This is part of Addendum #4

**SOUTHERN CONNECTICUT STATE UNIVERSITY
LOT #7 PARKING GARAGE
NEW HAVEN, CONNECTICUT
PROJECT: CF- RS - 273**

BID OPENING	1:00 P.M.	JUNE 16, 2010
ADDENDUM NUMBER 4	DATE OF ADDENDUM	JUNE 2, 2010

A CONCRETE CURB STOP
N.T.S.

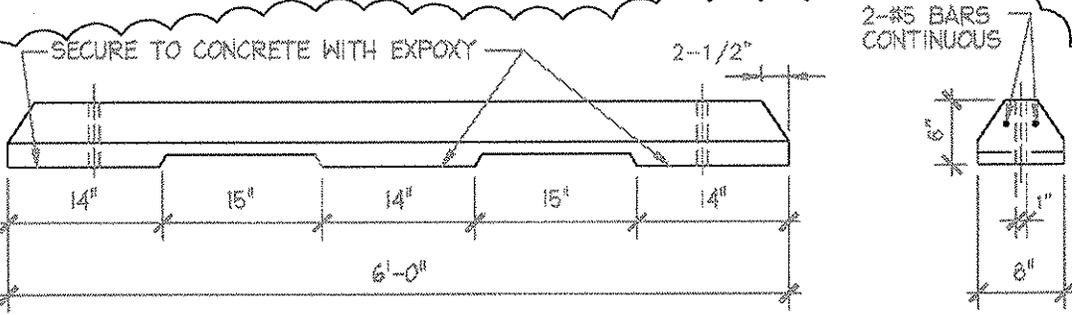
The following sketches are included:
ASK-1 (Clarification on curtain wall color and finish) Modifies General Notes on A5.02 & ~~ASK-2~~ (ADD: Wheel Stops at the end of all internal Handicapped parking spaces, typical). Modifies drawing A8.06, Key's into drawings A1.01 – A1.03
ASK-3 (Revised expansion joint model numbers – ZB(C/S Group) and LMS (MM Systems). Modifies drawing A9.02

1 TYP. HANDICAPPED ACCESSIBLE PARKING STALL - PAINTING PLAN
1/8" = 1'-0"

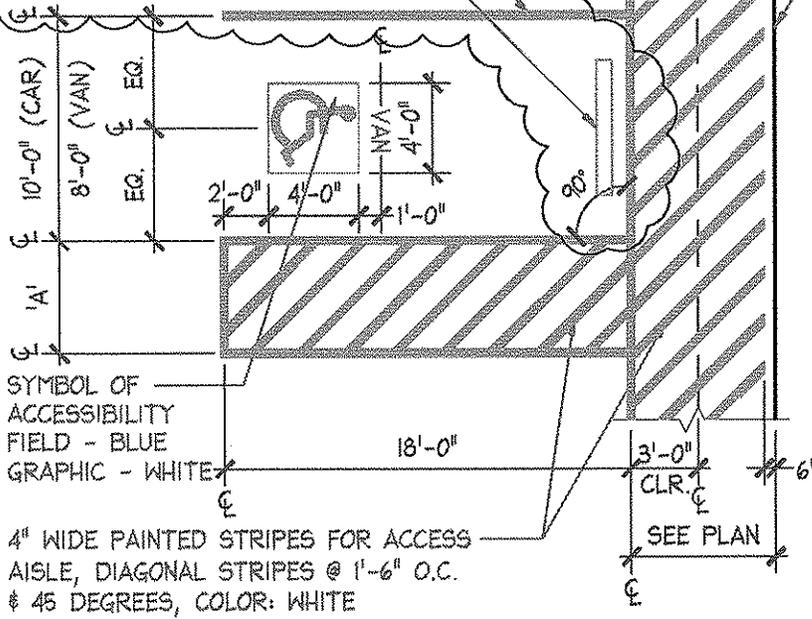
CONCRETE CURB STOP TYP. AT ALL H/C SPACES SEE DETAIL A

SNO BARRICADE™

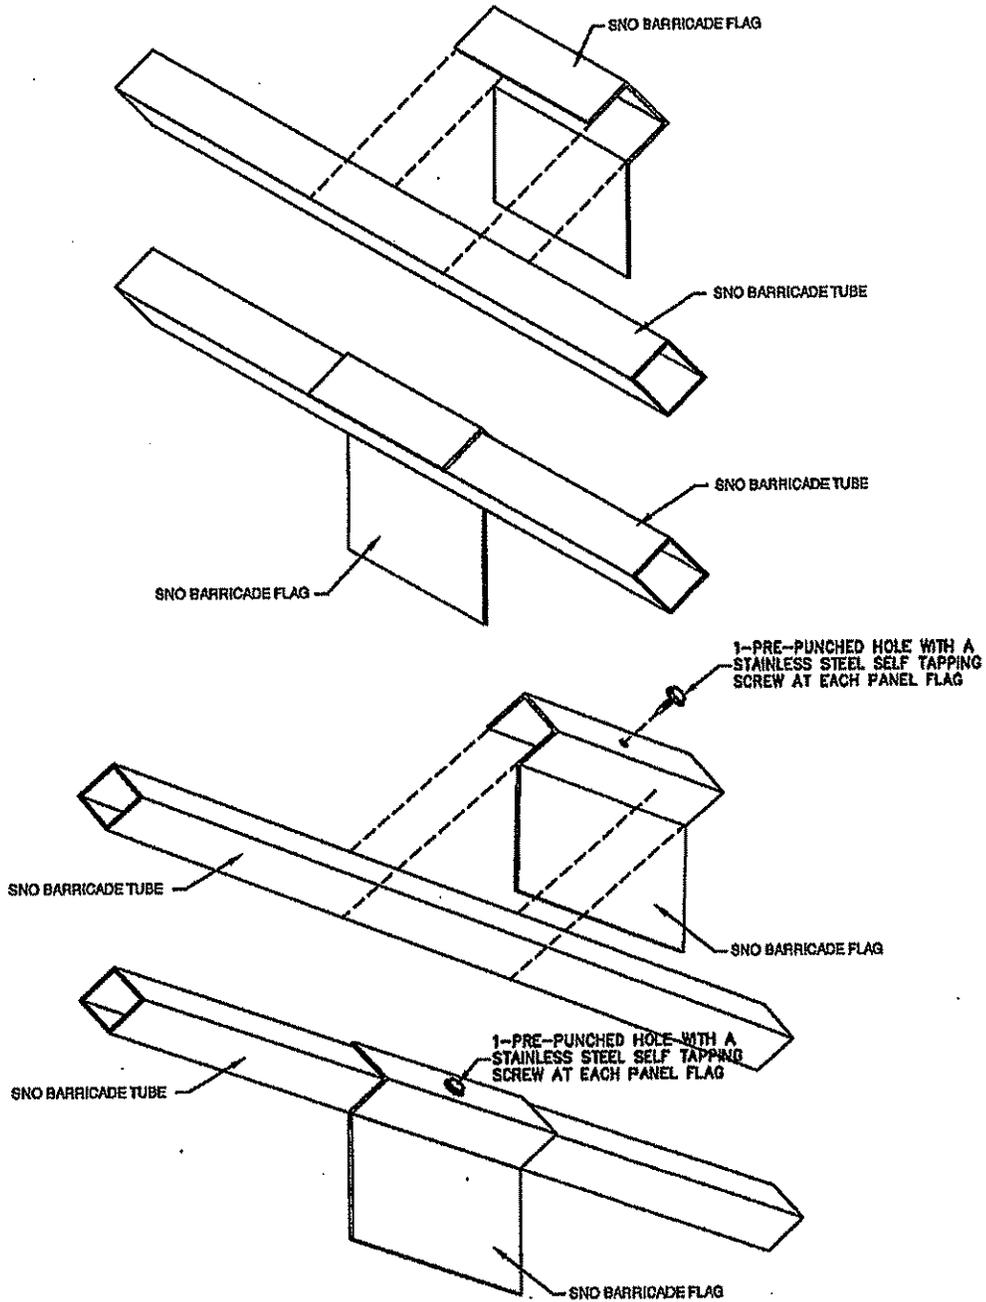
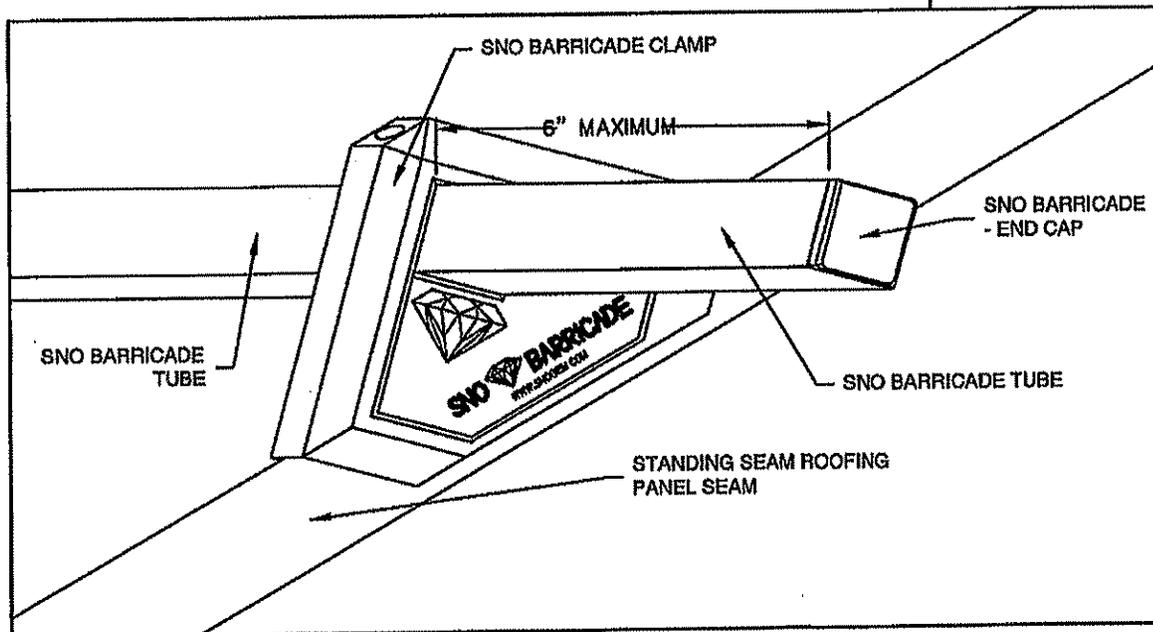
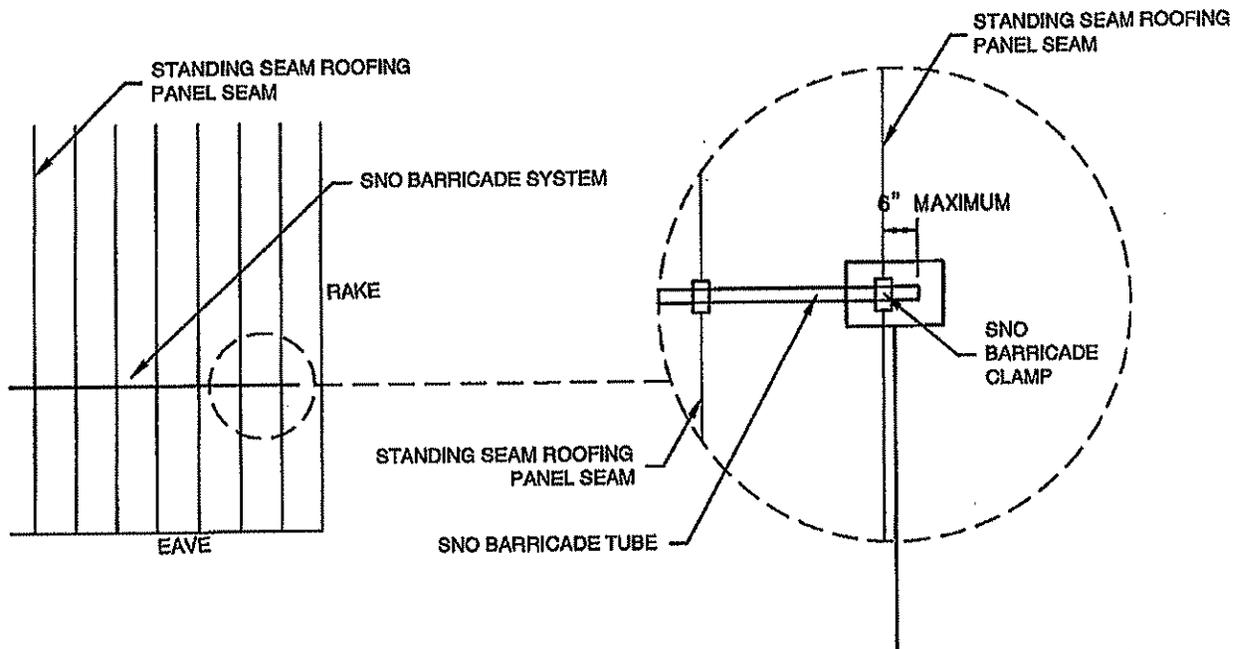
In Section 074113 Paragraph A.1.b. Add Sno-Barricade by Sno- Gem, Inc see attached approved Equal or Substituted Product Request for Sno-Barricade snow guards. See attached Substitute Product Request.
